REVISED STORMWATER DESIGN
RECEIVED NOV 2022. (1st Review)

PRELIMINARY Drainage Report and Stormwater Pollution Prevention Plan

East Town Crossing

City of Puyallup, Washington

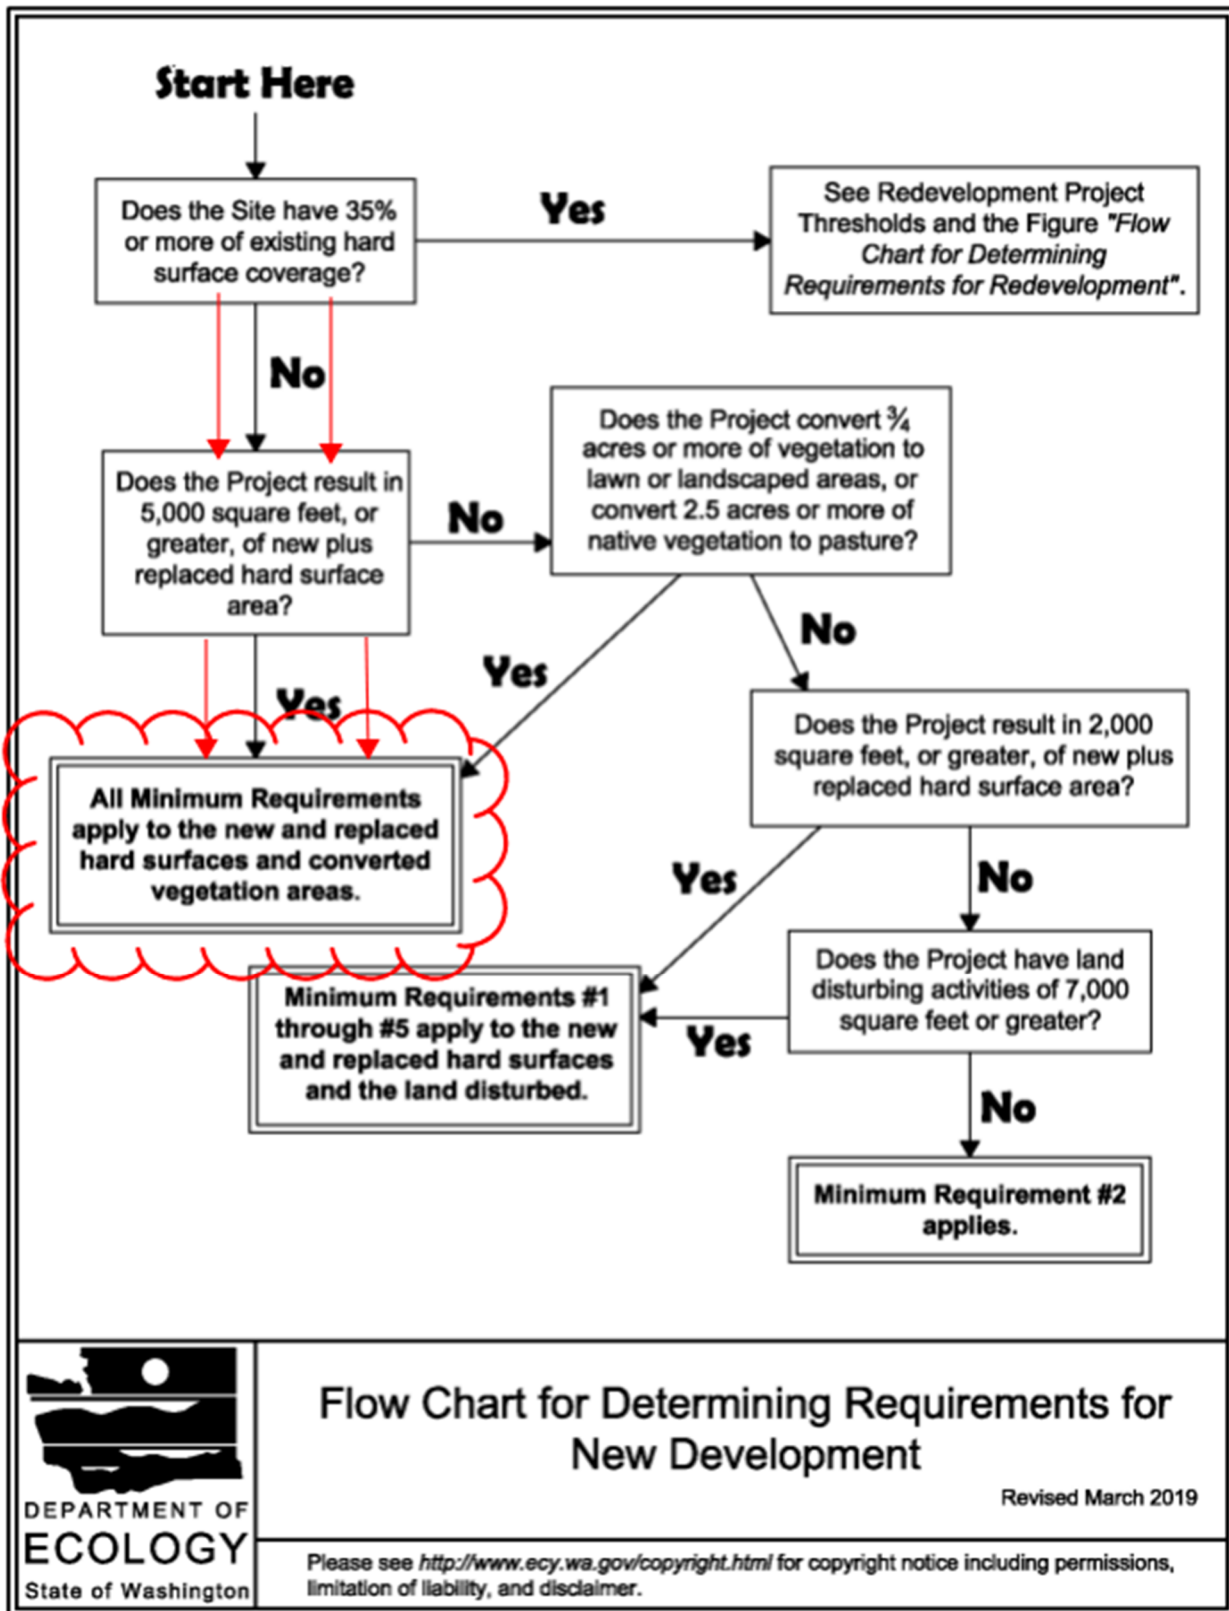
2019 Ecology Manual
as adopted by the City.
[Storm Rpt; Pg 6 of 148]

Figure 4: Grading and Drainage Plan

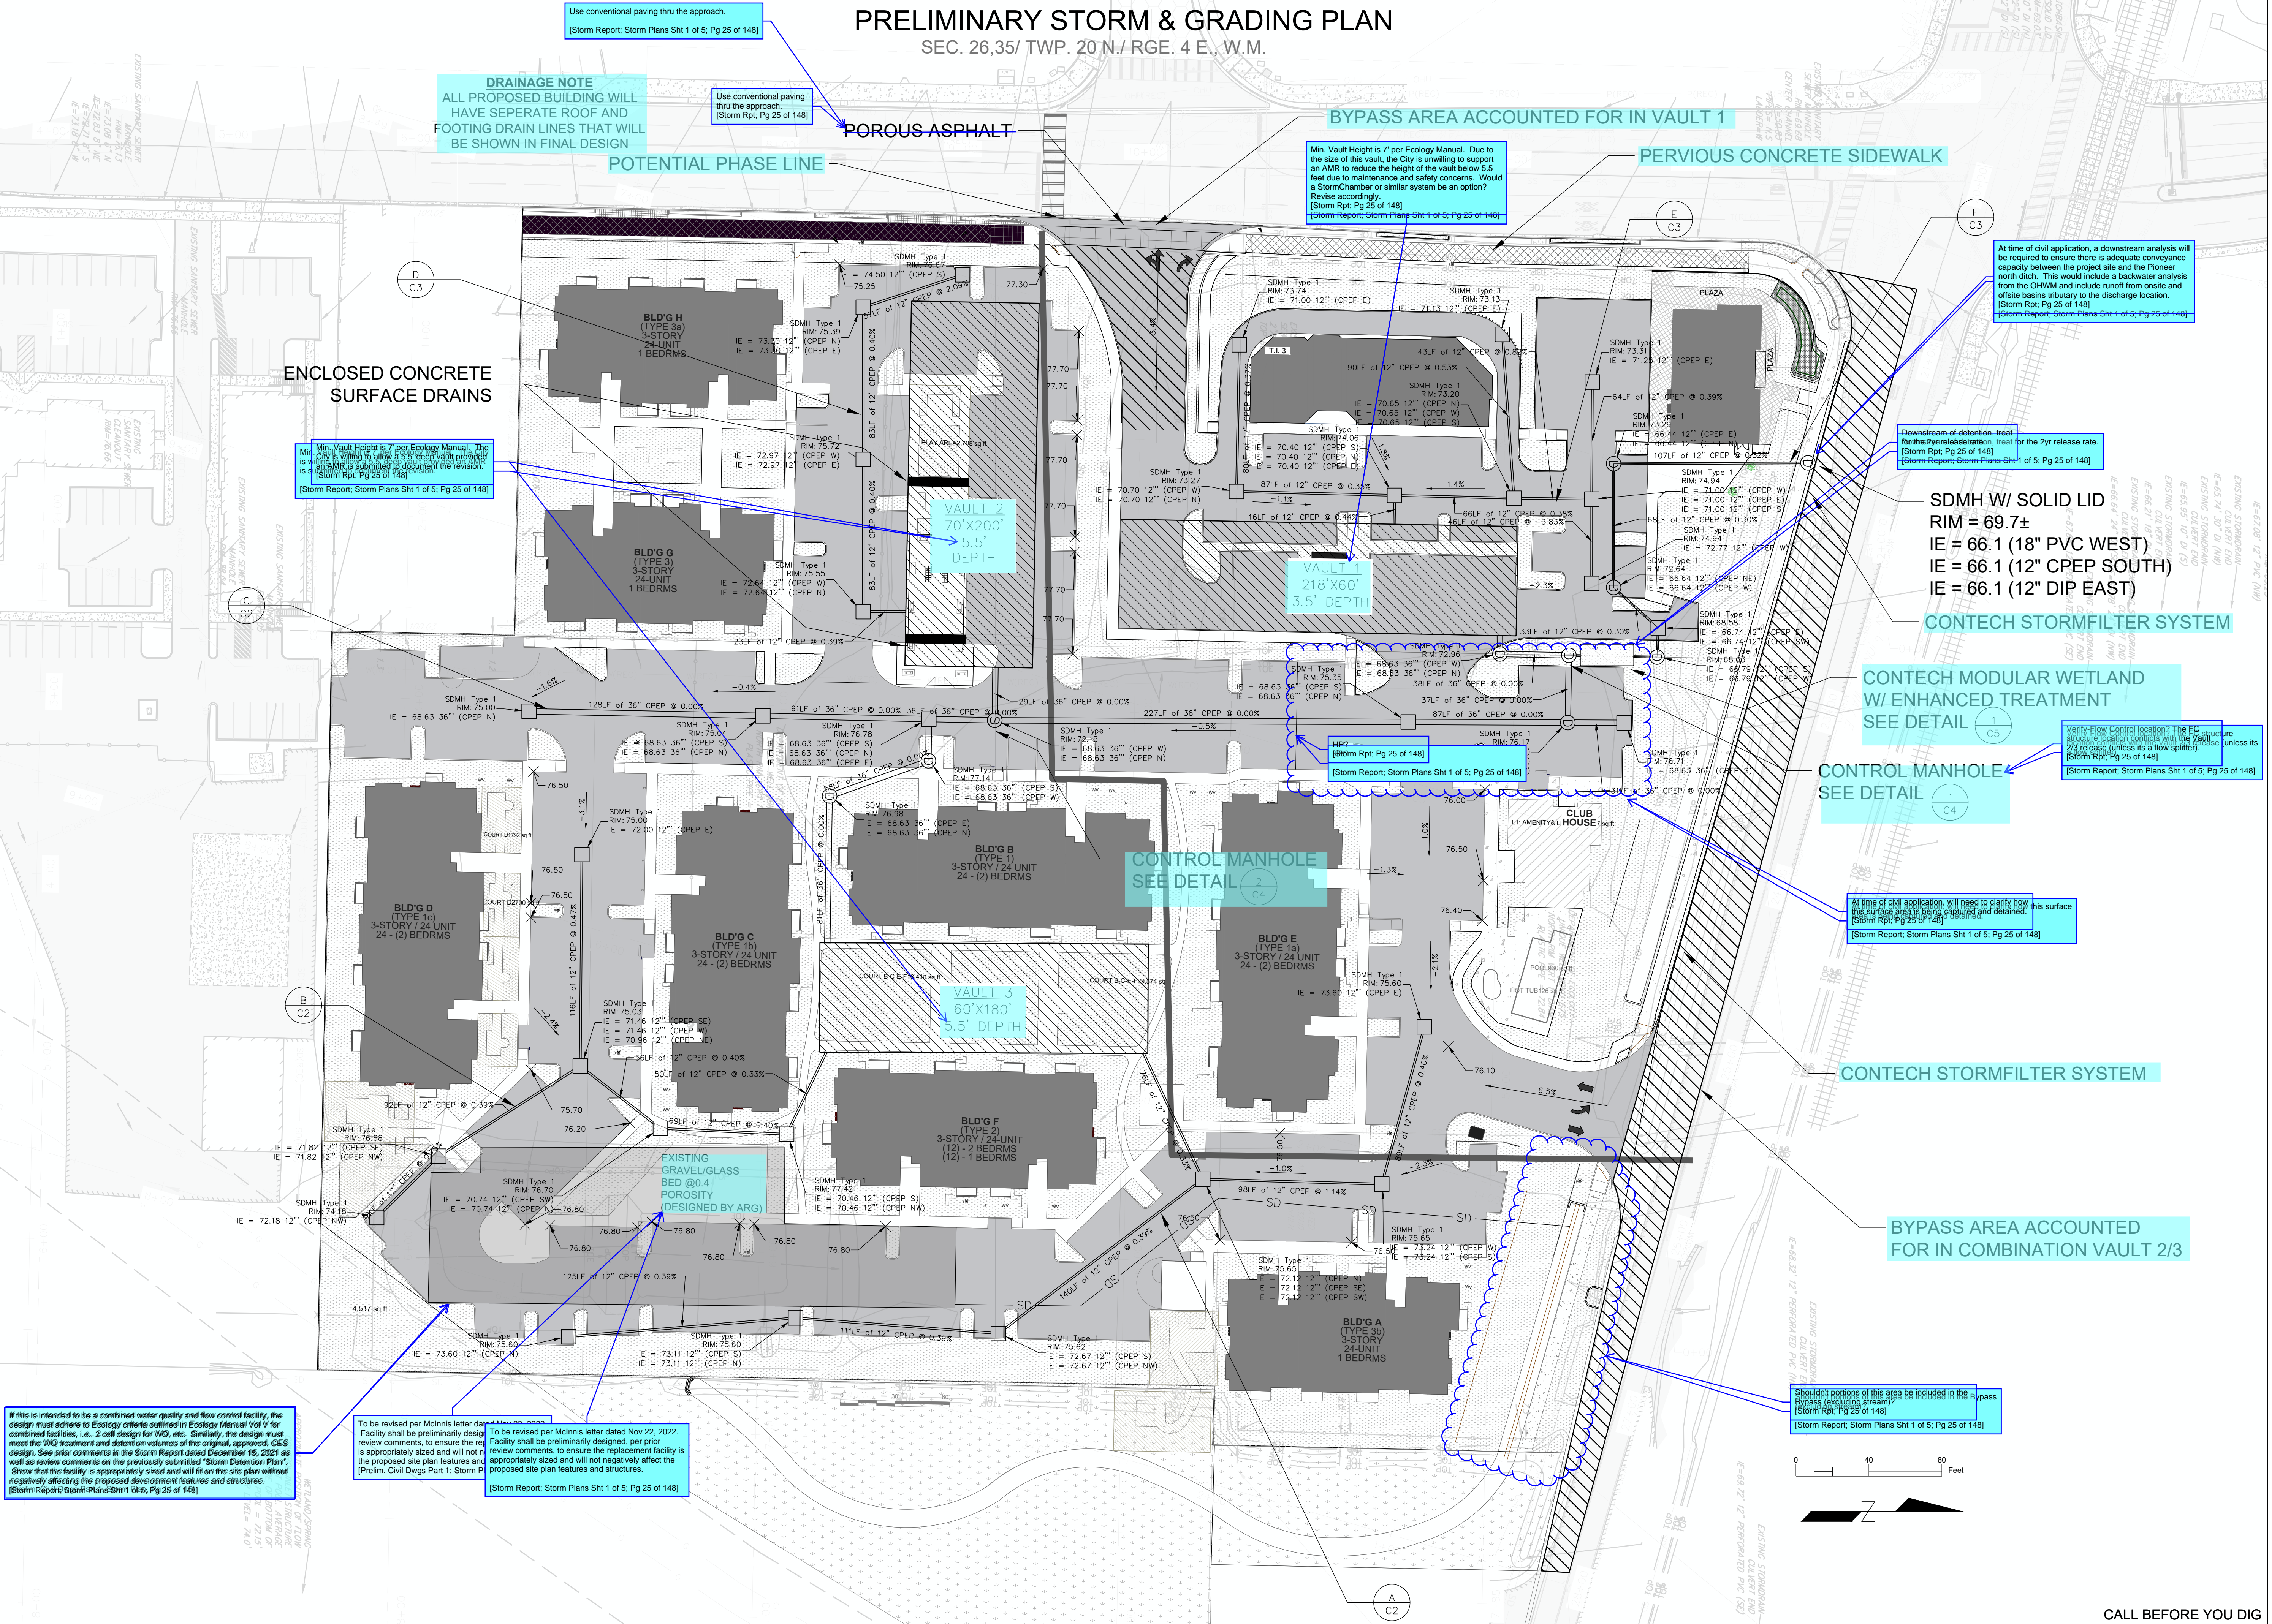
Use conventional paving thru the approach.
[Storm Report: Storm Plans Sht 1 of 5; Pg 25 of 148]

Min. Vault Height is 7' per Ecology Manual. Due to
the size of this vault, the City is unwilling to support
an AMR to reduce the height of the vault below 5.5
feet due to maintenance and safety concerns. Would
a StormChamber or similar system be an option?
Revise accordingly.
[Storm Rpt: Pg 25 of 148]
[Storm Report: Storm Plans Sht 1 of 5; Pg 25 of 148]

At time of civil application, a downstream analysis
will be required to ensure there is adequate conveyance
capacity between the project site and the Pioneer
north ditch. This would include a backwater analysis
from the CHWM and include runoff from onsite and
offsite basins tributary to the discharge location.
[Storm Rpt: Pg 25 of 148]
[Storm Report: Storm Plans Sht 1 of 5; Pg 25 of 148]

Min. Vault Height is 7' per Ecology Manual. The
City is willing to allow a 5.5' deep vault provided
is an AMR is submitted to document the revision.
[Storm Rpt: Pg 25 of 148]
[Storm Report: Storm Plans Sht 1 of 5; Pg 25 of 148]

Verify Flow Control location? The EC structure
location conflicts with the Vault 2
release (unless its a flow splitter).
[Storm Rpt: Pg 25 of 148]
[Storm Report: Storm Plans Sht 1 of 5; Pg 25 of 148]

At time of civil application, will need to clarify how
this surface area is being captured and detained.
[Storm Rpt: Pg 25 of 148]
[Storm Report: Storm Plans Sht 1 of 5; Pg 25 of 148]

Shouldn't portions of this area be included in the
bypass (excluding stream)?
[Storm Rpt: Pg 25 of 148]
[Storm Report: Storm Plans Sht 1 of 5; Pg 25 of 148]

If this is intended to be a combined water quality and flow control facility, the
design must adhere to Ecology criteria outlined in Ecology Manual Vol V for
combined facilities, i.e. 2 cell design for VQC, etc. Similarly, the design must
meet the VQC treatment and detention volumes of the original, approved, C&S
design. See prior comments in the Storm Report dated December 15, 2021 as
well as review comments on the previously submitted "Storm Detention Plan".
Show that the facility is appropriately sized and will fit on the site plan without
negatively affecting the proposed development features and structures.
[Storm Report: Storm Plans Sht 1 of 5; Pg 25 of 148]

To be revised per McInnis letter dated Nov 22, 2022.
Facility shall be preliminarily designed. Facility shall be preliminarily designed, per prior
review comments, to ensure the replacement facility is
appropriately sized and will not negatively affect the
proposed site plan features and structures.
[Prelim. Civil Design Part 1: Storm P
[Storm Report: Storm Plans Sht 1 of 5; Pg 25 of 148]
